Access Compliance Report

Public Rights-of-Way

Intersection ID: 10041630	Main Street: WHITEHALL_PARK_DR	Cross Street: N/A	Location: S
ADA ID: EC4D01DD3FA6	Ramp Type: PerpDiag	Initial Pass/Fail: Fail	Overall Compliance: No
		Severity Score: 37.5

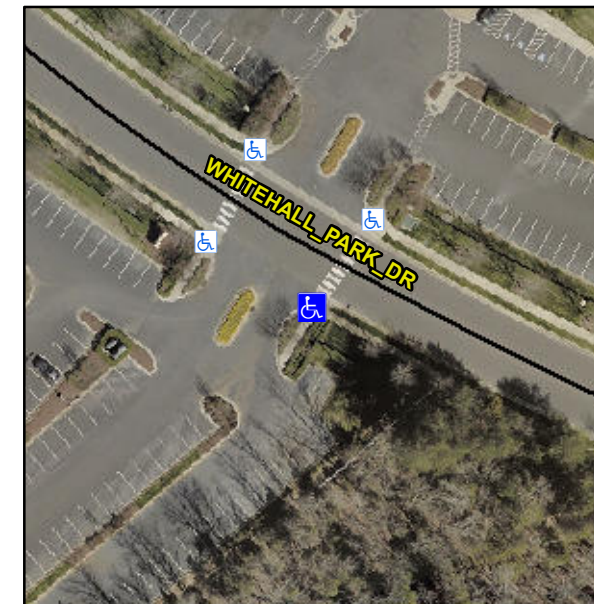
R304.2.2, R304.5.3

Compliance	Description	Data	Compliance	Description	Data
N/A	Ramp Length (in)	72.0	No	Ramp Slope (%)	8.8
Yes	Ramp Width (in)	48.0	No	Ramp XSlope (%)	7.6
N/A	Flare Type LT	N/A	N/A	Flare Type RT	N/A
N/A	Flare Slope LT (%)	N/A	N/A	Flare Slope RT (%)	N/A
N/A	Flare Traversable LT?	N/A	N/A	Flare Traversable RT?	N/A
N/A	Landing Length (in)	N/A	N/A	DWS Provided?	N/A
N/A	Landing Width (in)	N/A	N/A	DWS Contrast?	N/A
N/A	Landing Slope (%)	N/A	N/A	DWS Length (in)	N/A
N/A	Landing X Slope (%)	N/A	N/A	DWS Full Width?	N/A
N/A	Landing Curb? (Y/N)	N/A	N/A	DWS Offset (in)	N/A
N/A	Shared Landing?	N/A			
N/A	Gutter Ponding?	N/A	N/A	Gutter Slope (%)	N/A
N/A	Gutter Lip Ht (in)	N/A	N/A	Gutter X Slope (%)	N/A
N/A	Painted X Walk1?	Yes	N/A	Painted X Walk2?	No
	X Walk 1 Direction	To NE		X Walk 2 Direction	To NW
N/A	X Walk 1 Width (in)	96.0	N/A	X Walk 2 Width (in)	N/A
	X Walk 1 Slope (%)	10.5		X Walk 2 Slope (%)	2.9
	X Walk 1 X Slope (%)	0.1		X Walk 2 X Slope (%)	8.2

Remove & Replace Curb Ramp With Two New Directional Ramps or Equivalent.
